I HEREBY CERTIFY THIS STRUCTURE WAS BUILT ACCORDING TO PLANS EXCEPT AS NOTED HEREIN.

PROJECT NO. 97122902  
CLEVELAND COUNTY  
#32 STATION 16+39.16-1- = 14+00.00-1-2

GENERAL DRAWING FOR WIDENING OF NC-16 OVER US-74

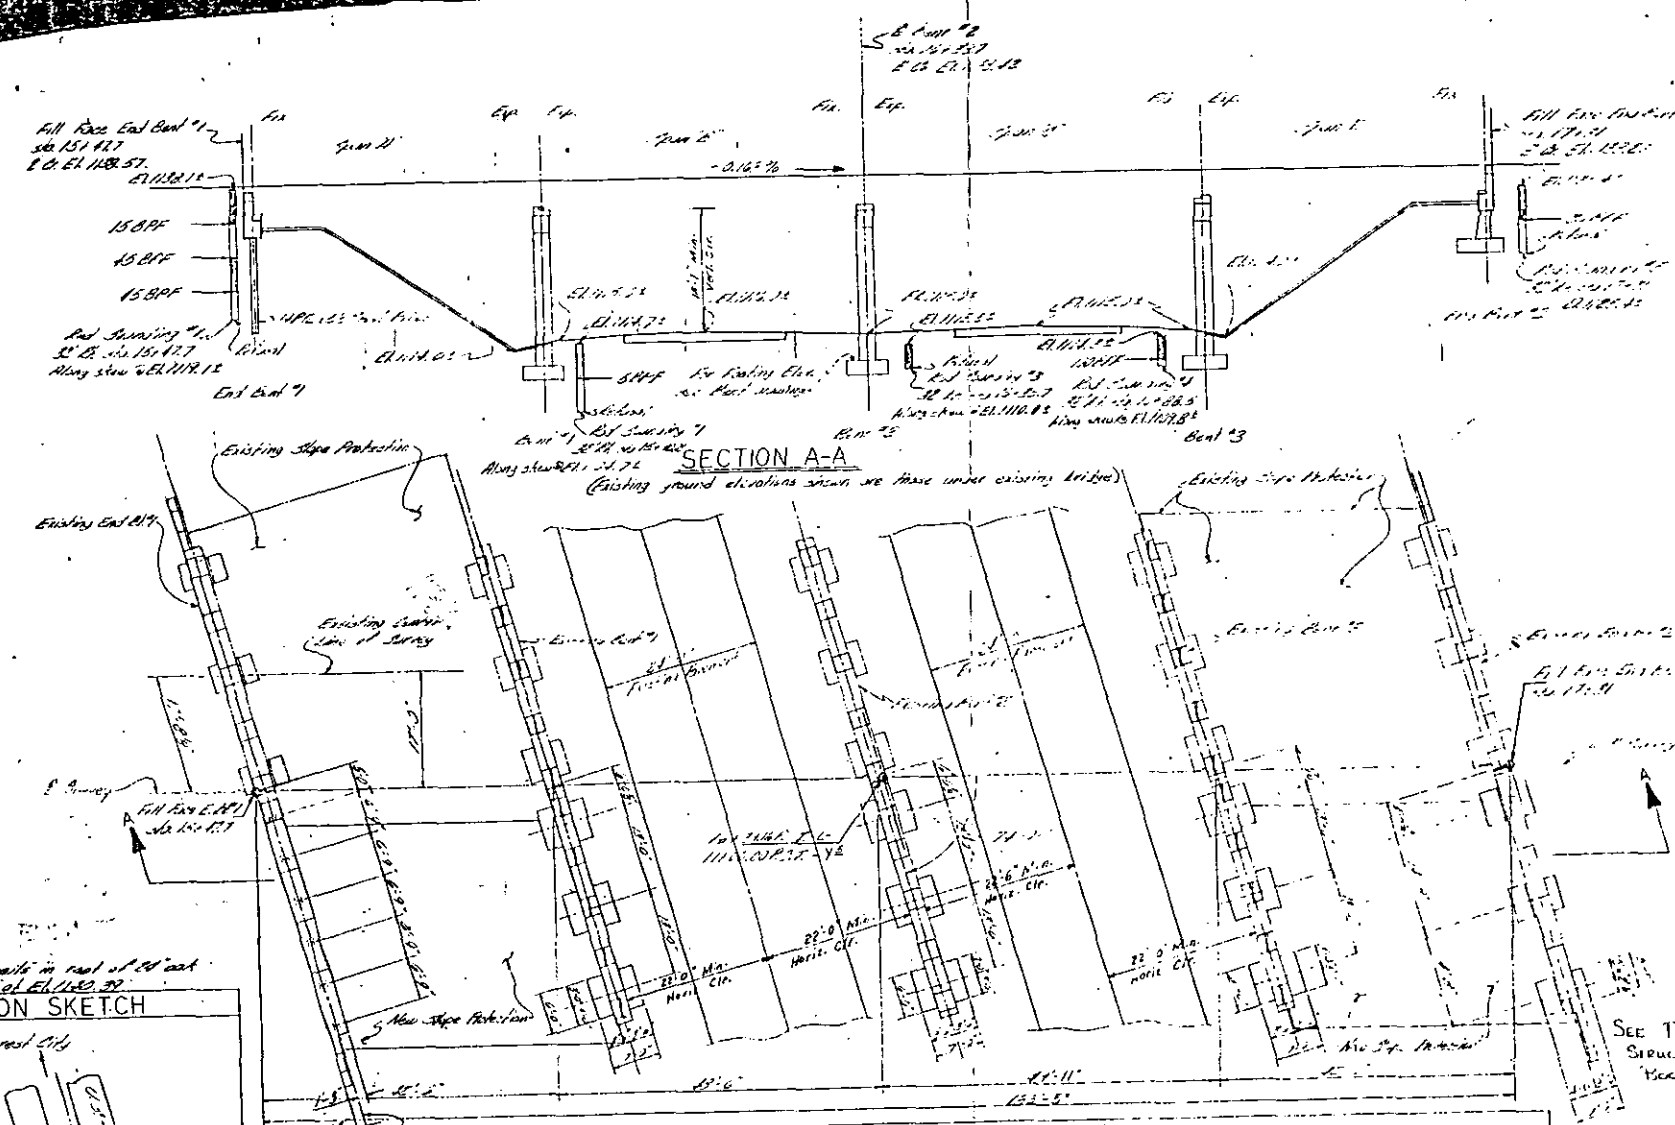
MR. C. B. PATTEN, AREA STRUCTURE ENGINEER, DISCUSSED PAYMENT FOR UNCLASSIFIED EXCAVATION FOR STRUCTURE WITH THE RALEIGH OFFICE. IT WAS DECIDED THAT NO PAYMENT WOULD BE MADE FOR THIS ITEM EXCEPT FOR SLOPING THE EXISTING CUT SLOPE TO MAKE IT TIE TO THE NEW SLOPE PROTECTION.

Rev 1: To change span length, span C and overall length bridge. By R.E.K. 12-1-70 11-12-70

SUPERSTRUCTURE PLAN  
SPAN "A" OR SPAN "D"

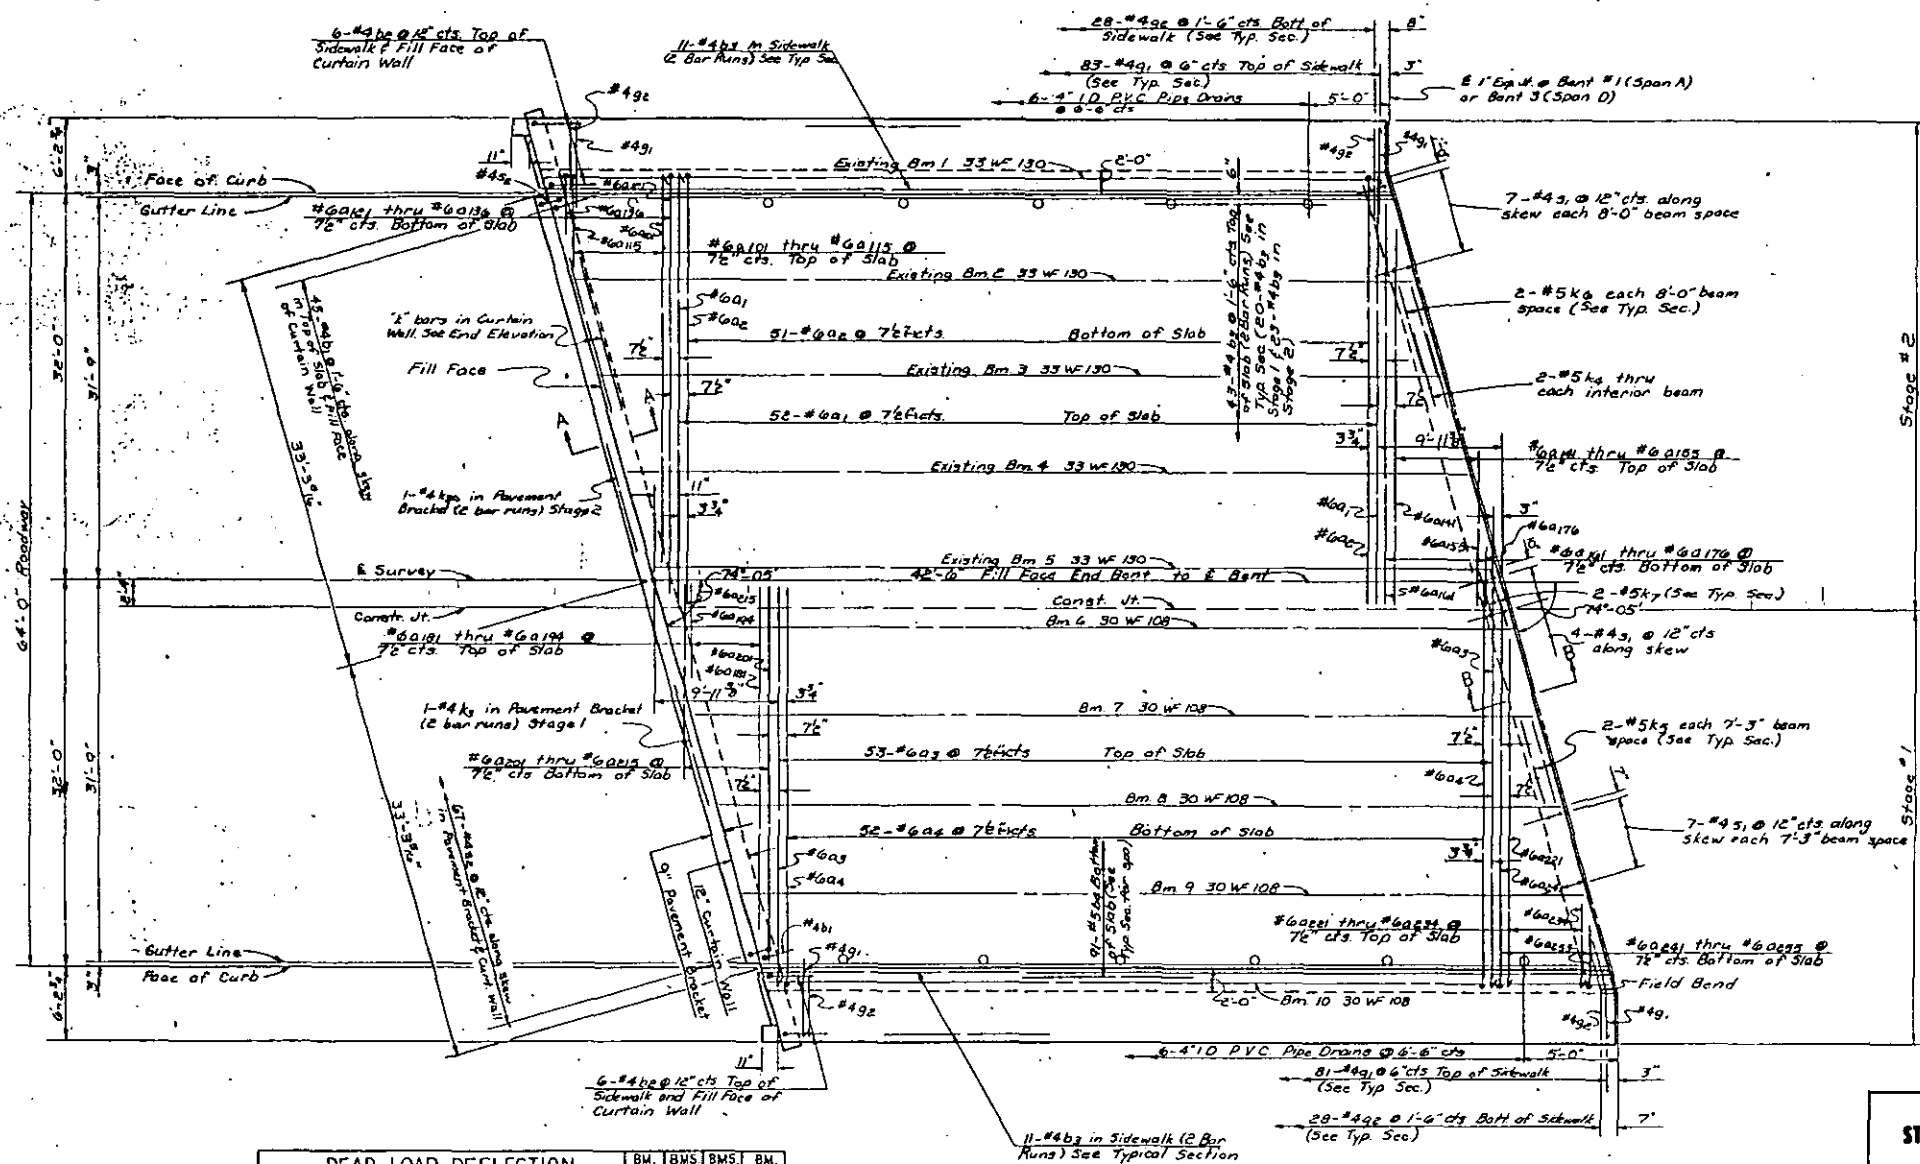
NO SHOP CAMBER REQUIRED. TURN NATURAL MILL CAMBER UP

STATE OF NORTH CAROLINA  
 STATE HIGHWAY COMMISSION  
 SUPERSTRUCTURE  
 PLAN-SPAN C

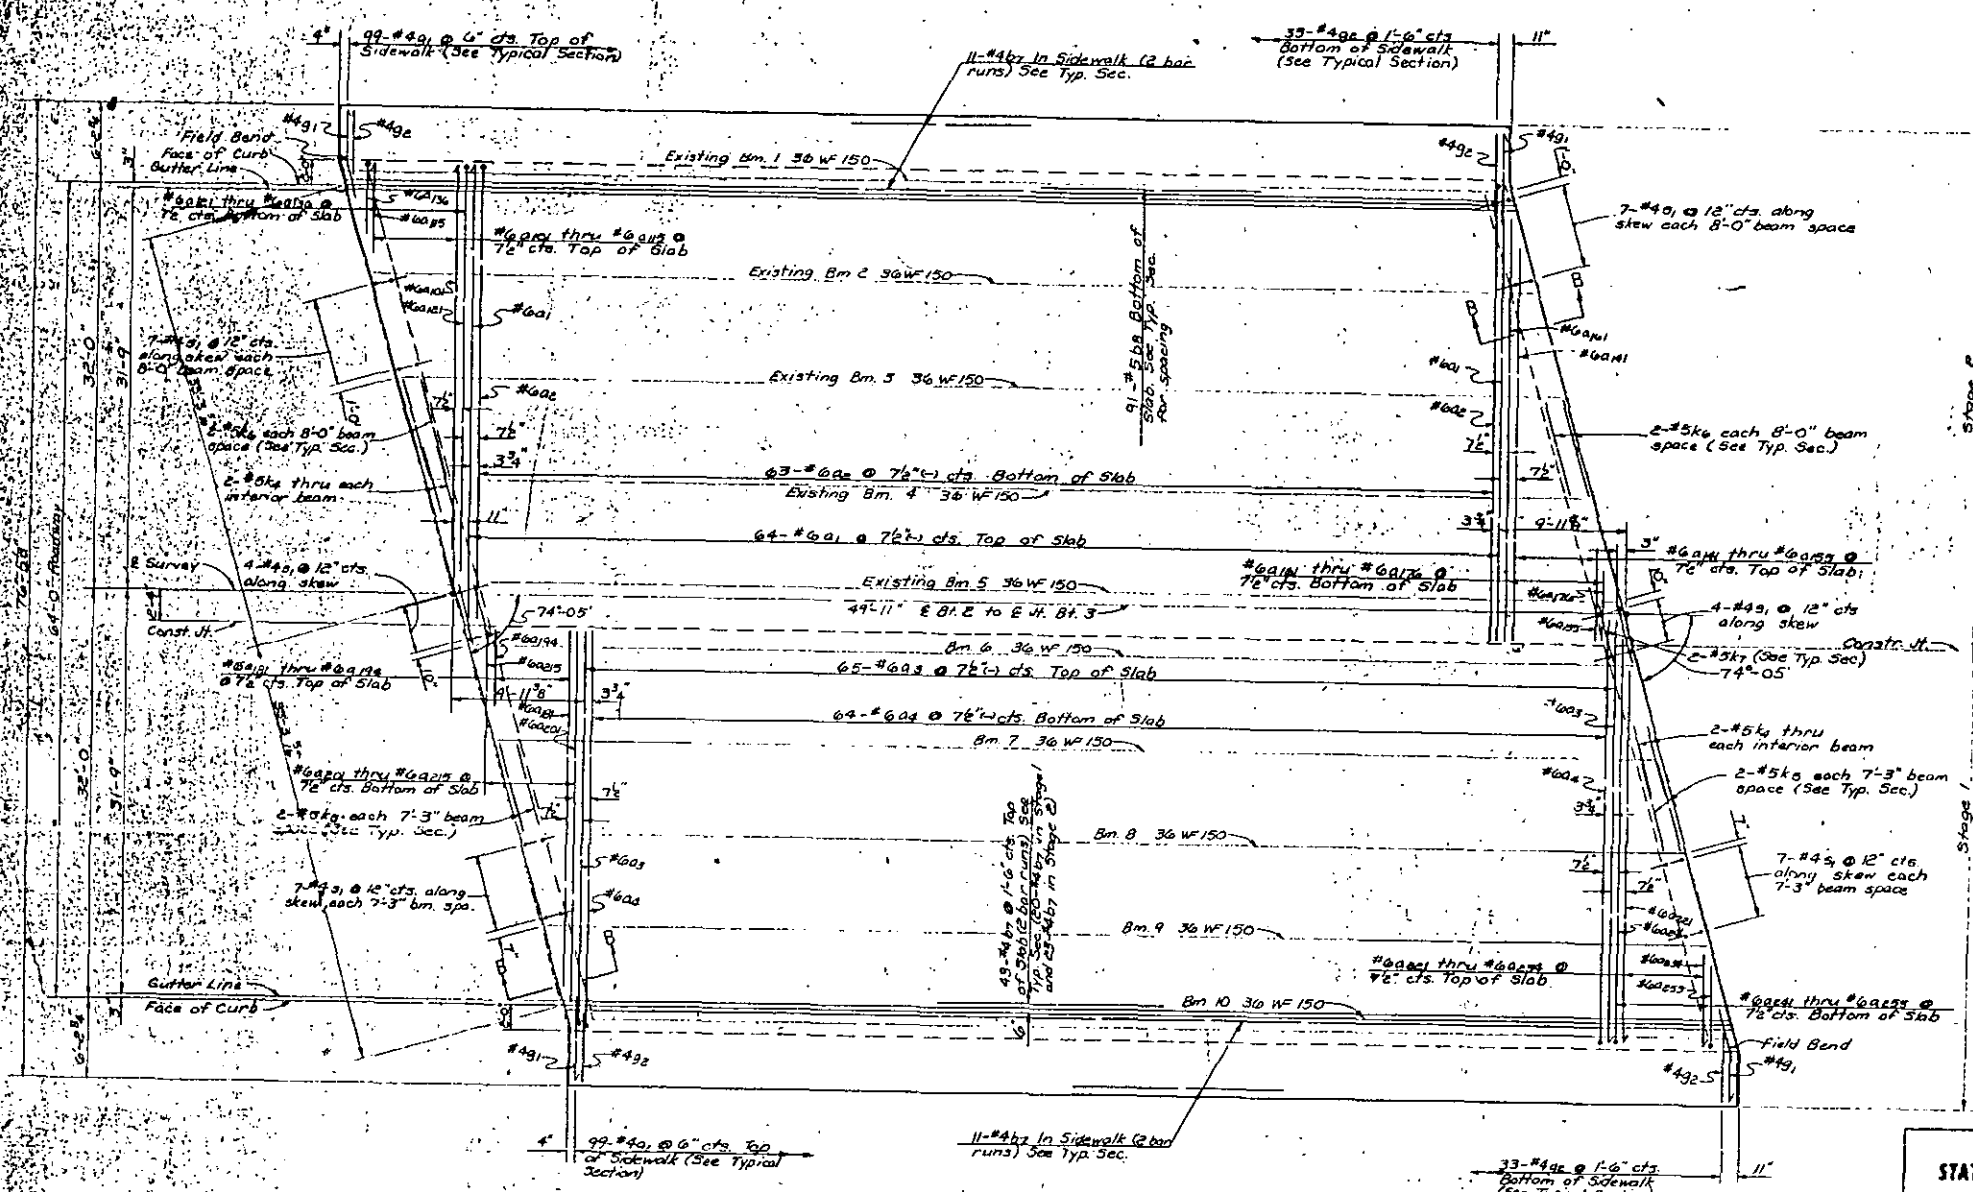
Revision No 1: To change Span C Length By REX By M.C. 12.12.72

FRAMING PLAN

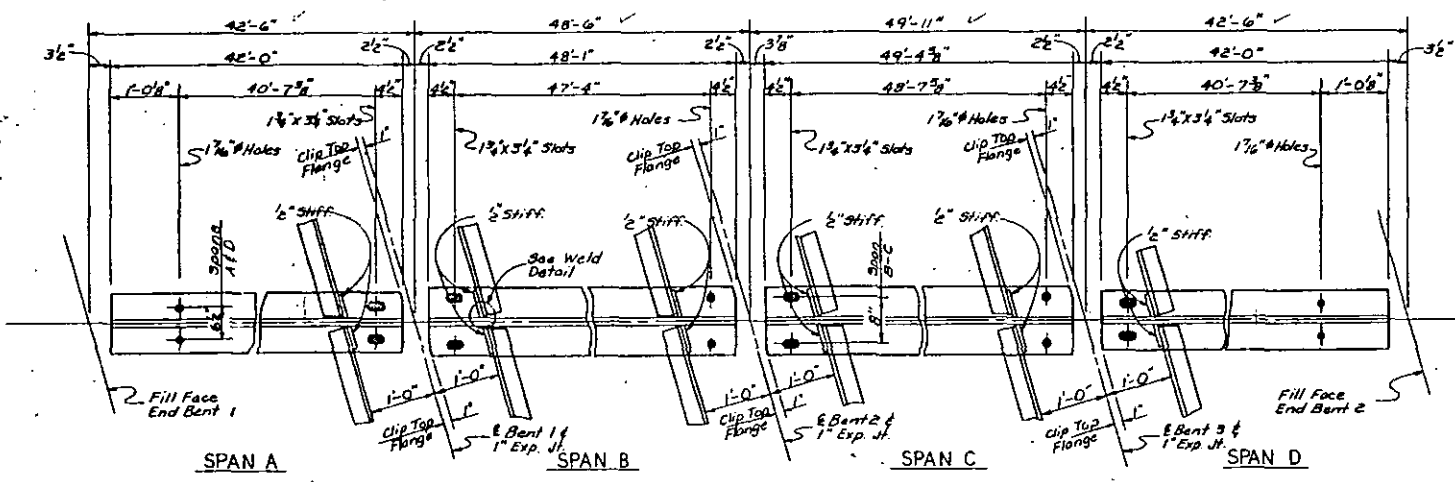
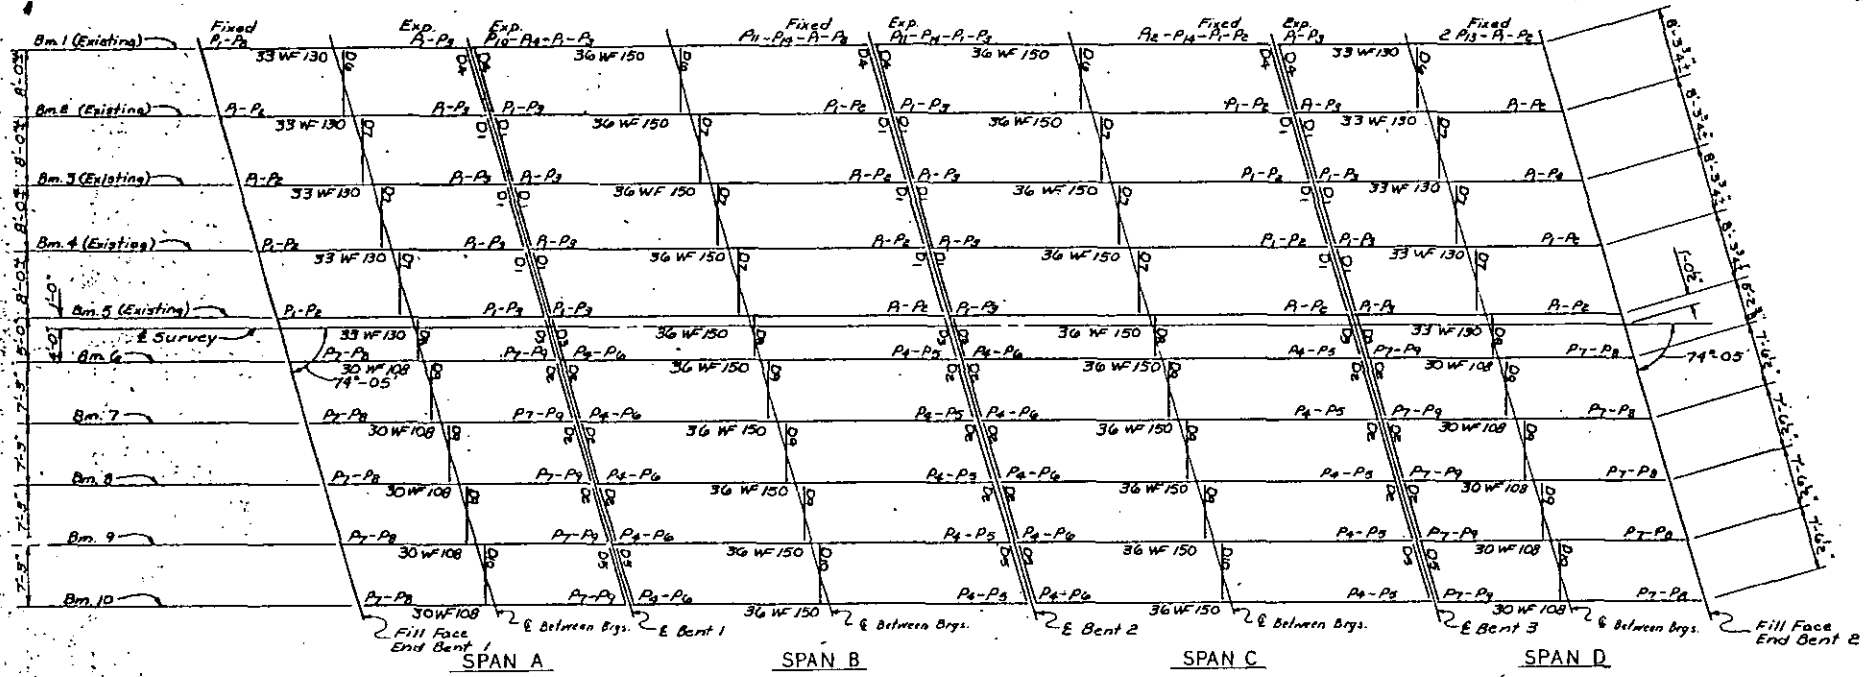
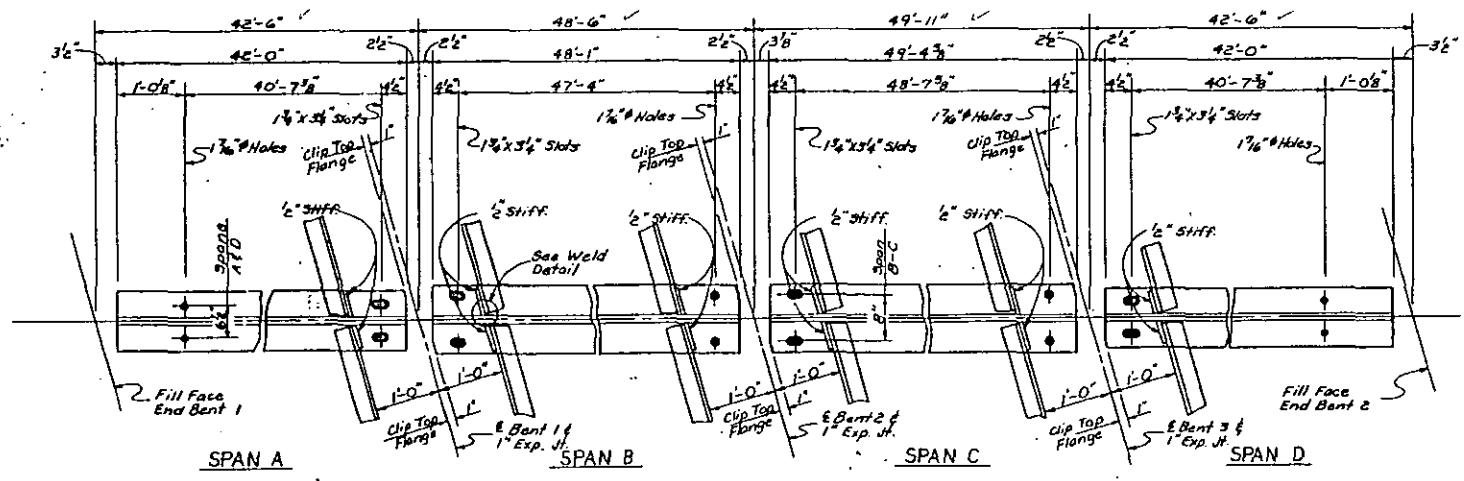
Rev. 1: Revised to change dimension E.H. to end of beam for Side of 2 and Span length Span C.  
 By REK. / By MJC

Rev 1: Revised to change dimension E.H. to end of beam for Side St 2 and Span length Span C.  
By REK. JBy WJC

RAIL PLAN

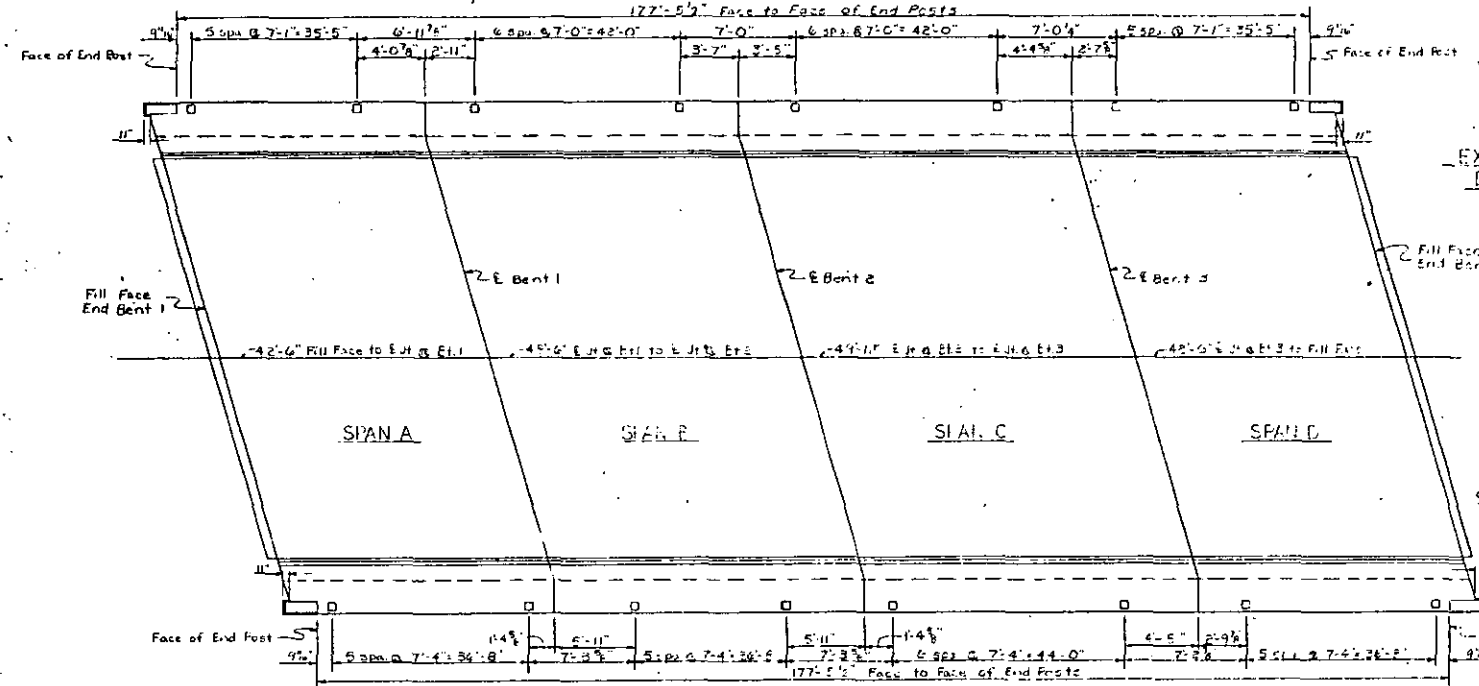
Rev 1: Revised to change dimension Face to Face of End Posts, and End Base to 1/2" Pad and Span Length Span C. By REXBY

STATE OF NORTH CAROLINA STATE HIGHWAY COMMISSION	DATE: AUGUST 1988
STANDARD 3 BAR METAL RAIL	BY: JAJ ✓ BY: M.C. (1-B-71)
REVISION NO. 8: TO ADD BOTTOM STAINLESS STEEL WASHERS.	BY: JAJ ✓ BY: M.C. (1-B-71)
REVISION NO. 9: TO CHANGE DIMENSION END POST BASE TO 1" POST.	BY: REK. BY: WKC.

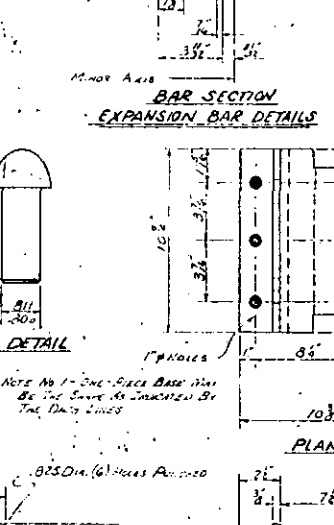
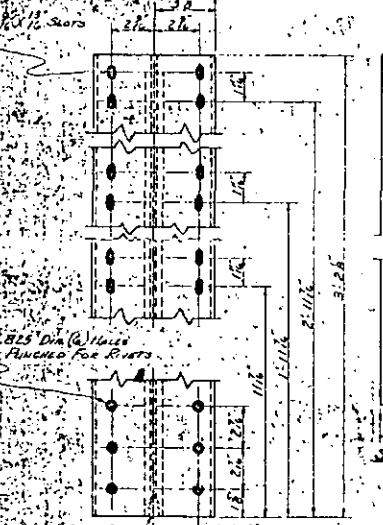
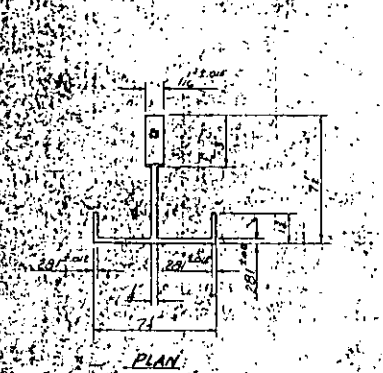
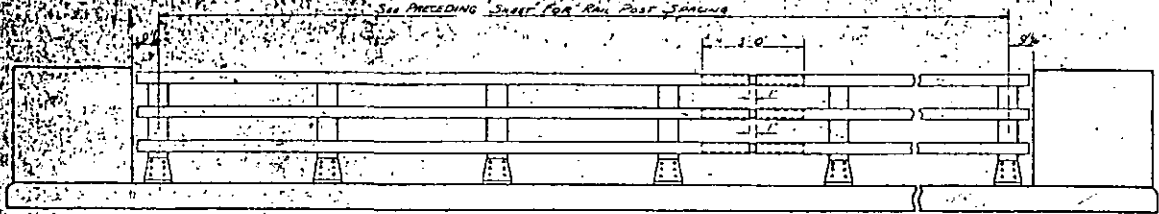
REVISION NO. 7: TO ALLOW USE OF ALLOY 6351-T5 BY JAJ (6-3-70).  
 REVISION NO. 8: TO ADD BOTTOM STAINLESS STEEL WASHERS. BY JAJ ✓ BY M.C. (1-B-71).  
 REVISION NO. 9: TO CHANGE DIMENSION END POST BASE TO 1" POST. BY REK. BY WKC.

STATE OF NORTH CAROLINA			
STATE HIGHWAY COMMISSION			
RALEIGH			
STANDARD METAL RAIL			
OPTIONAL PRESET ANCHOR UNITS			
DECEMBER 1970			
NO.	BY	DATE	REVISIONS
1	J.A.J.	2-4-71	1
2	J.A.J.	3-15-71	2
3	J.A.J.	3-19-71	3

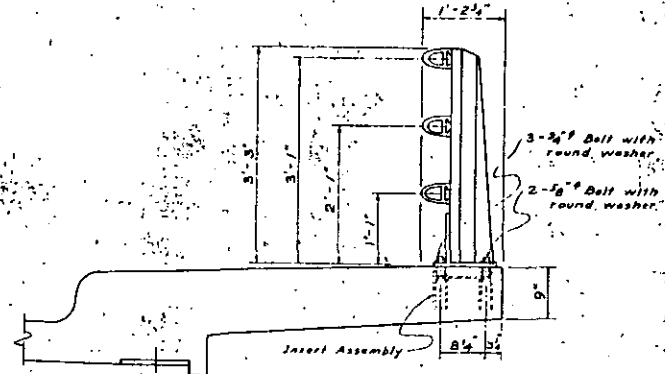
Revision NE 1: Revised to change Preset Anchor for 1-Bar Metal Rail. 2-4-71 By J.A.J. /BY J.L.S.

Revision NE 2: Revised to change note concerning tightening of bolts. 3-15-71 By J.A.J. /BY J.L.S.

Revision NE 3: Revised to change weld symbol. 3-19-71 By J.A.J. /BY J.L.S.
